ADDENDUM #1 – FEBRUARY 26, 2025

RE: CITY OF PORT ORFORD
American Legion Building Remodel
Project #18.27.3

FROM: HGE ARCHITECTS, Inc.
333 South 4th Street
Coos Bay, Oregon 97420
541-269-1166

M2.1

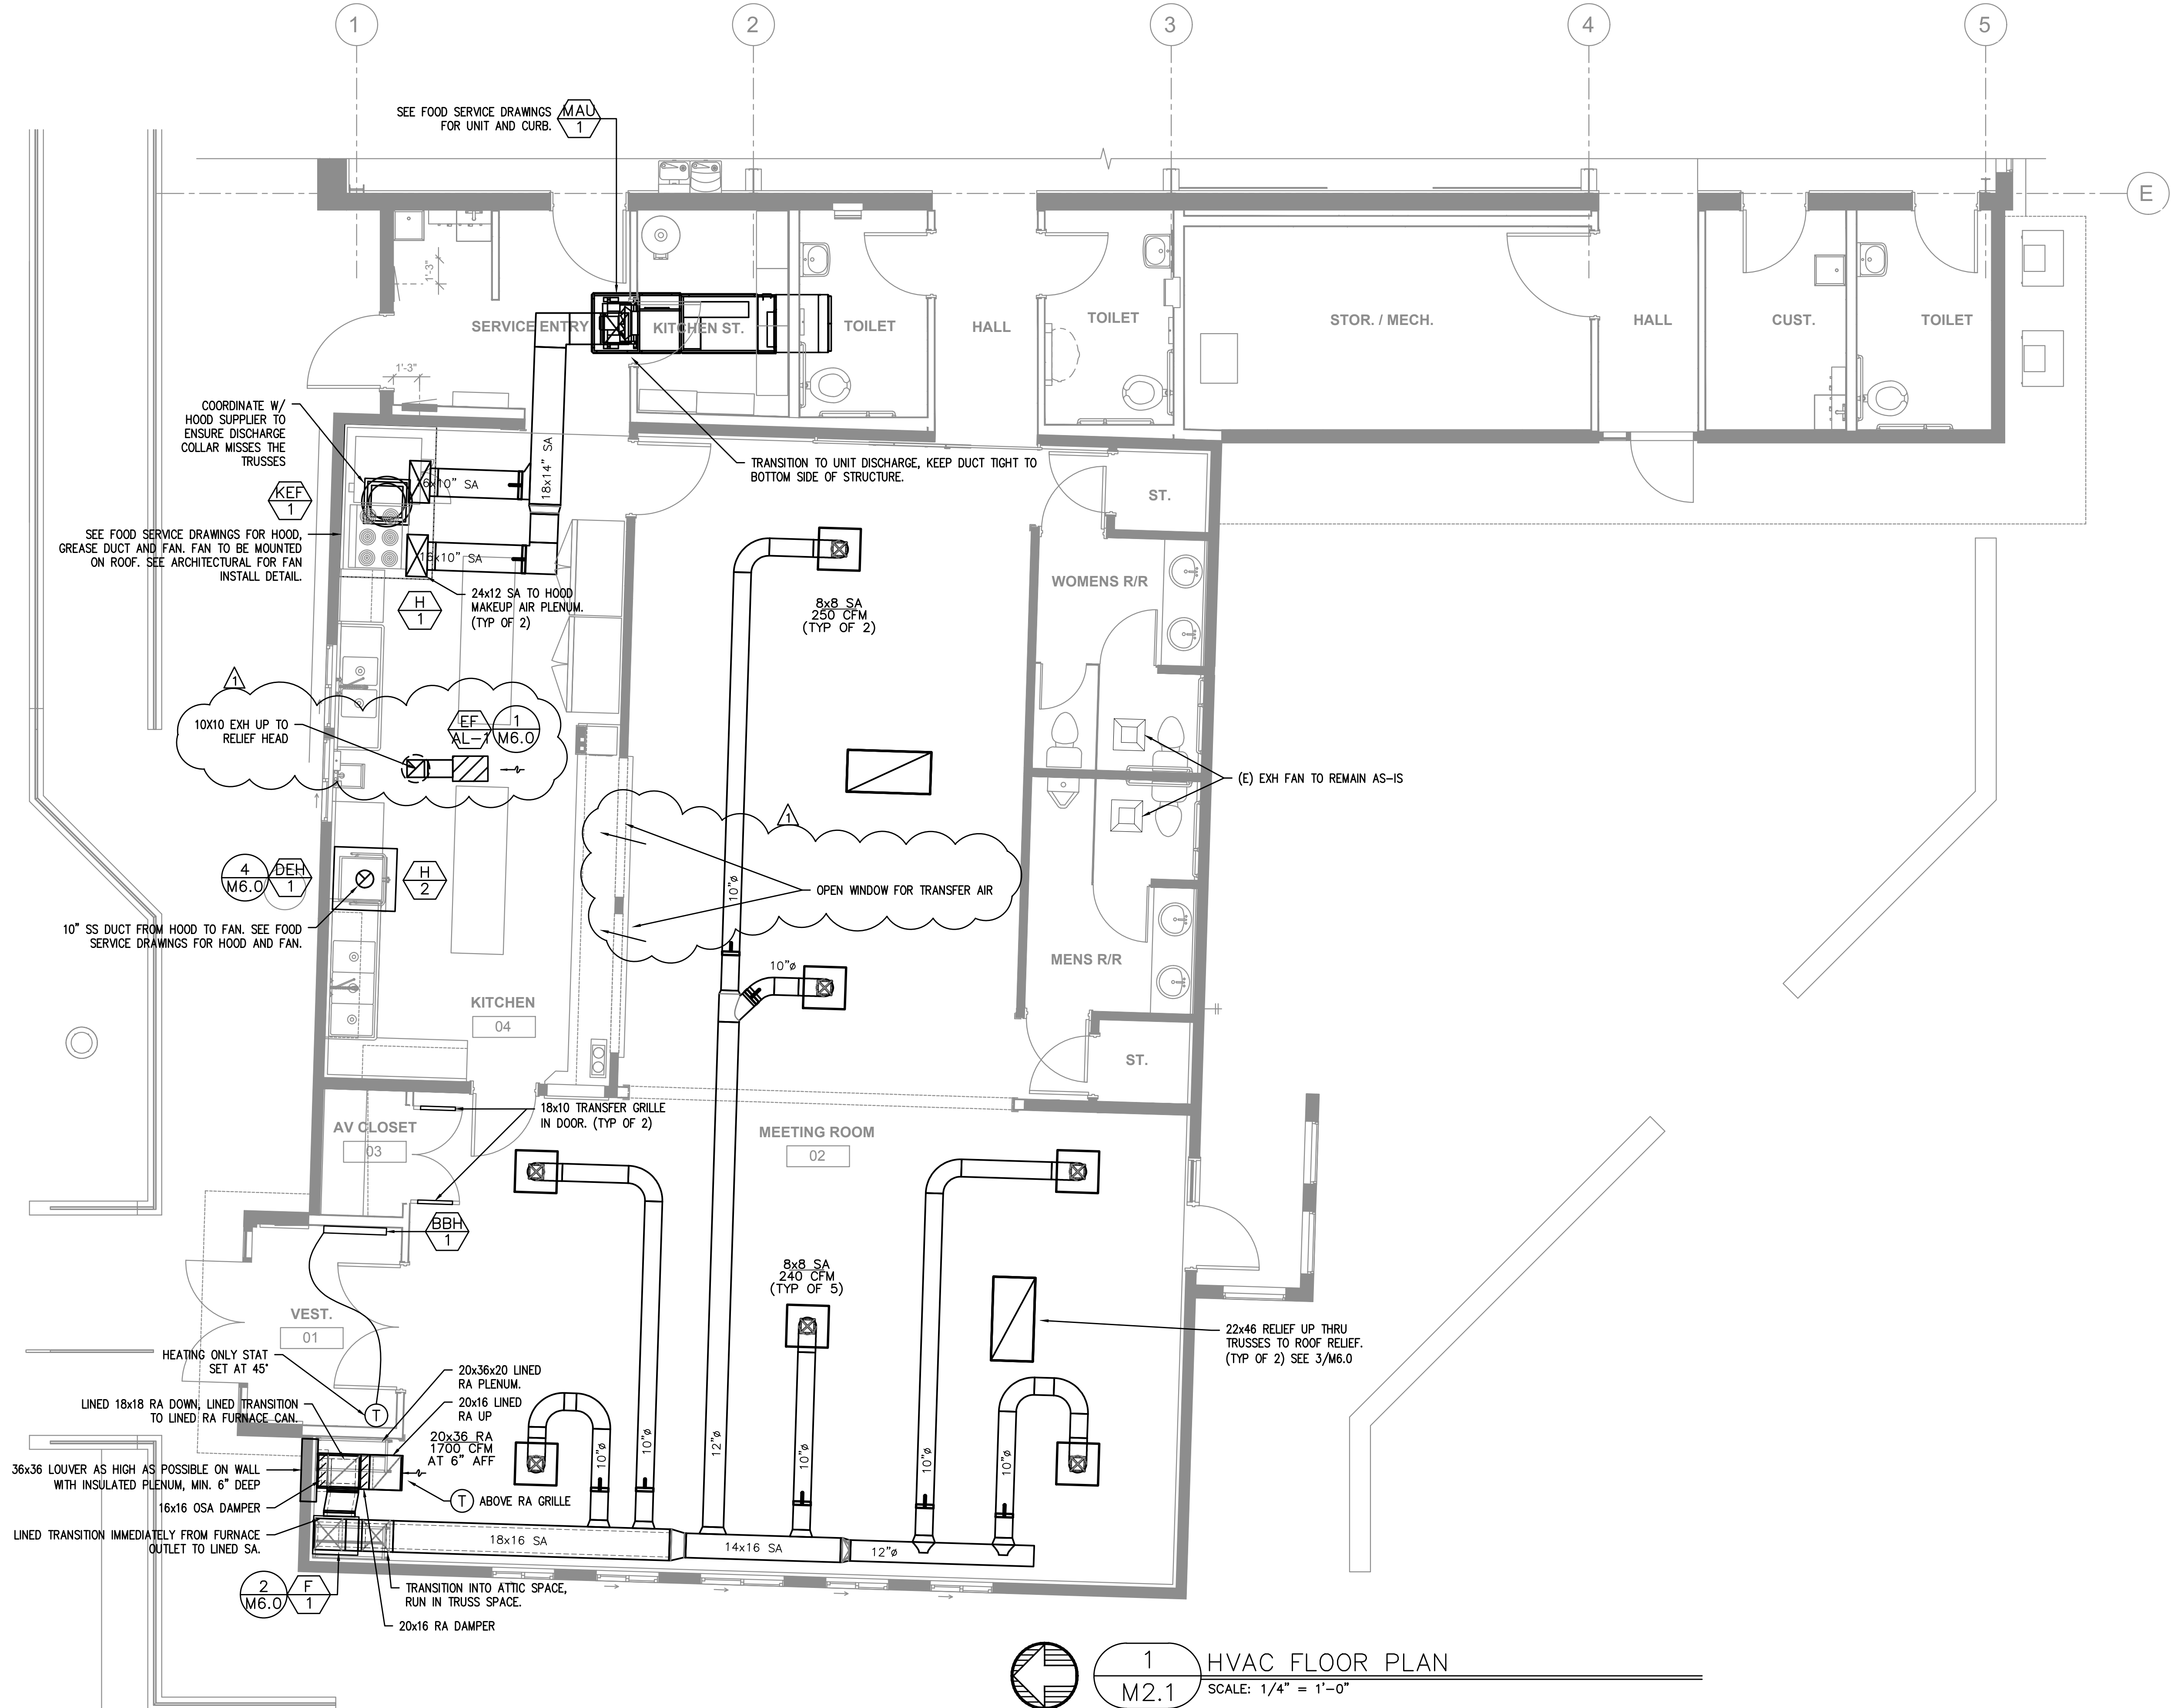
CR
 - b. At Wall Legend, DELETE “Shear Walls, see Structural.”
3. **Sheet A2.4 Enlarged Kitchen Plans, Enlarged Kitchen Plan – Existing/Demo:** At existing kitchen windows, ADD the following note: “Remove existing kitchen windows. Rough openings to be relocated and windows replaced – see North Elevation on Sheet A4.1.”
4. **Sheet A4.1 Exterior Elevations:** REPLACE notes “Paint siding & trim, repair rot, typ. (Alt. Bid.)” with “Paint siding & trim, typ.” Painting is to be base bid.
5. **Sheet A5.1 Details, Details 6 & 7:** REPLACE notes “2x6 wall w/ 5/8” gyp. bd. & plywood sheathing per structural,” with “2x6 wall w/ 5/8” gyp. bd. & 1/2” plywood sheathing.”
6. **Sheet P6.0 Plumbing Schedules and Details:** In Plumbing Connection Schedule, KS-2 Remarks, REPLACE “Hand” with “Hand Sink, see 22-4000.”
7. **Sheet M2.1 HVAC Floor Plan:** REPLACE with the attached revised Sheet in its entirety.
